AGENDA
Historic Yorktown Design Committee

Virtual Meeting
Zoom
May 20, 2020
7:00 PM

1. Call to Order
2. Roll Call
3. New Business
 - a. Election of Officers
4. Approval of Minutes
 - a. **February 19, 2020 meeting**
5. Old Business
6. Applications for Certificates of Appropriateness
 - a. **Application No. HYDC-174-20, Apostolos Demetry, 220 Church Street**
 - b. **Application No. HYDC-173-20, Veronica W. and Michael D. Lulofs, 210 Smith Street**
7. Reports / Member Concerns
8. Adjourn

YORK COUNTY VIRGINIA
 PLOT PLAN OF
 NORTH-EASTERLY 2/3 OF LOT 62
 YORKTOWN
 FOR
 PERFORMANCE CONTRACTING

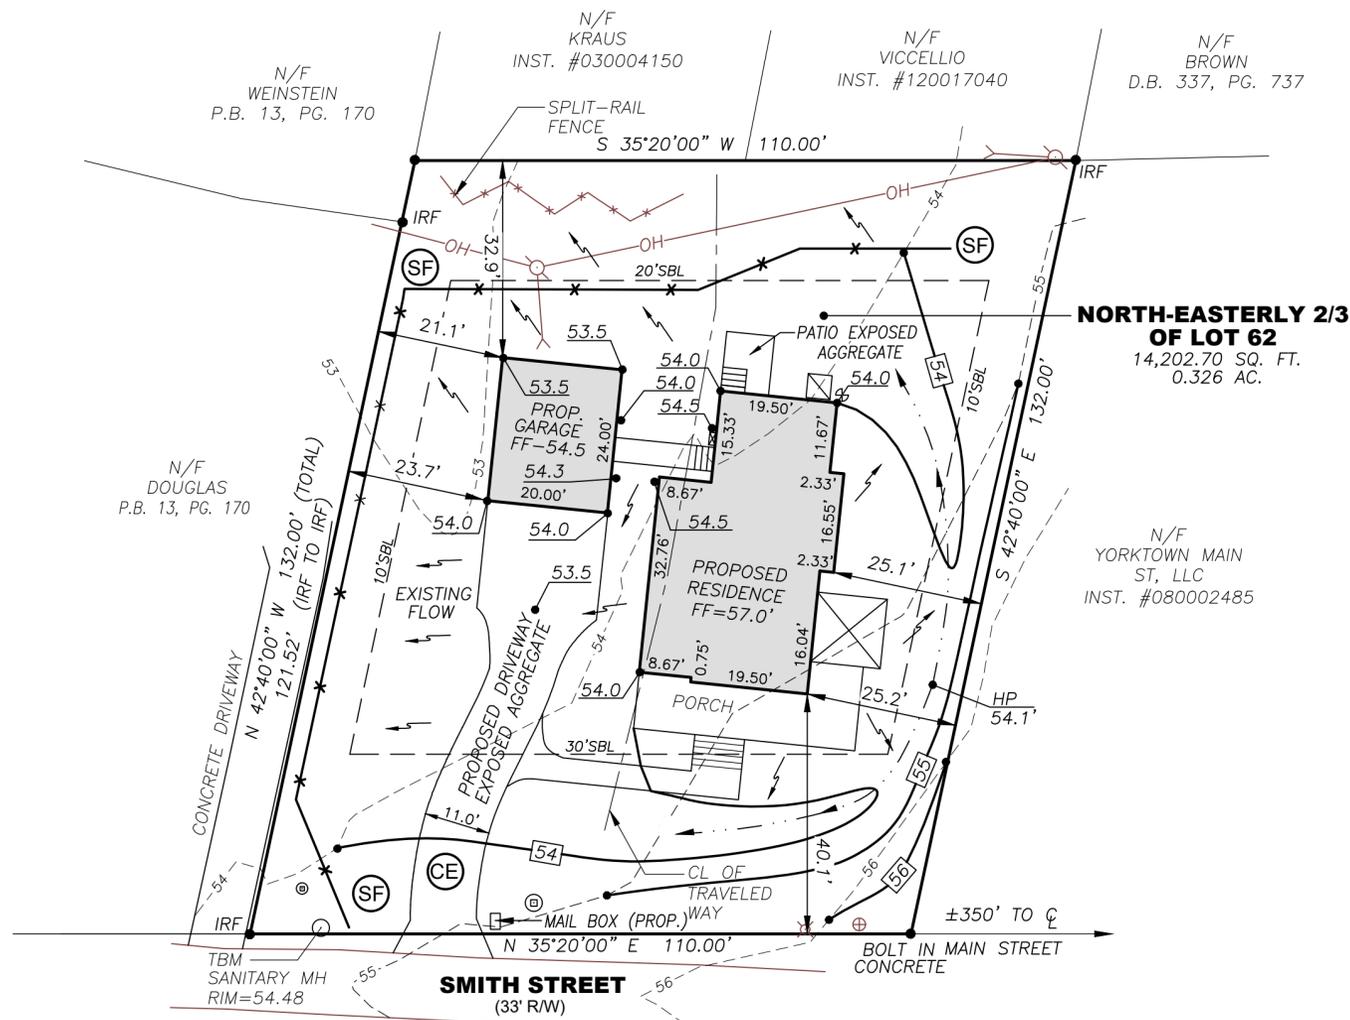
- Please place the location of the HVAC and other outside utilities on the plan and if in the side yard, it will need to be screened through fencing and landscaping. **Will be completed. HVAC location will be right rear.**

4 ALLEY ELEVATION
1/4" = 1'-0"

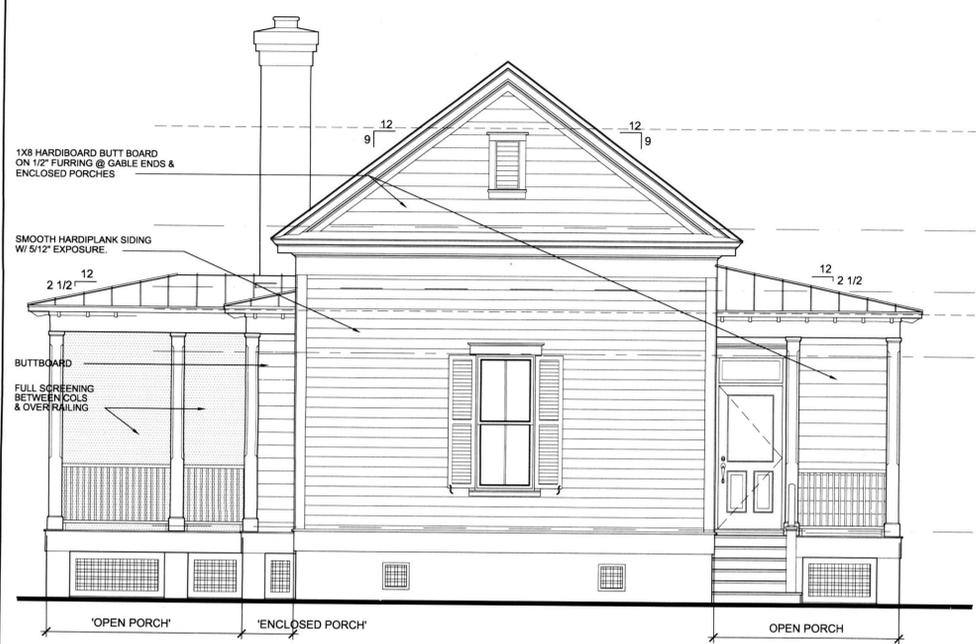
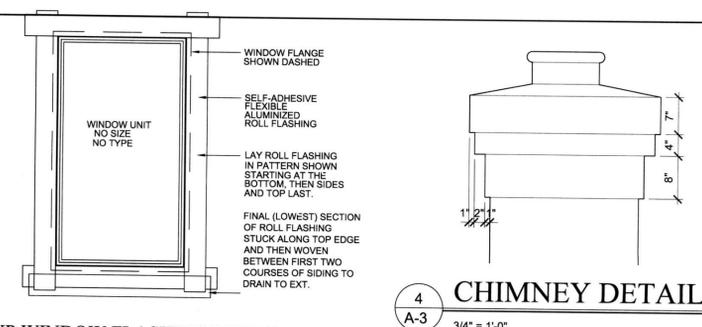
- Most of the windows on Smith Street are six over six divided light windows, do you plan to do something similar or will you only have the two panels. **Yes 6/6 style is confirmed.**
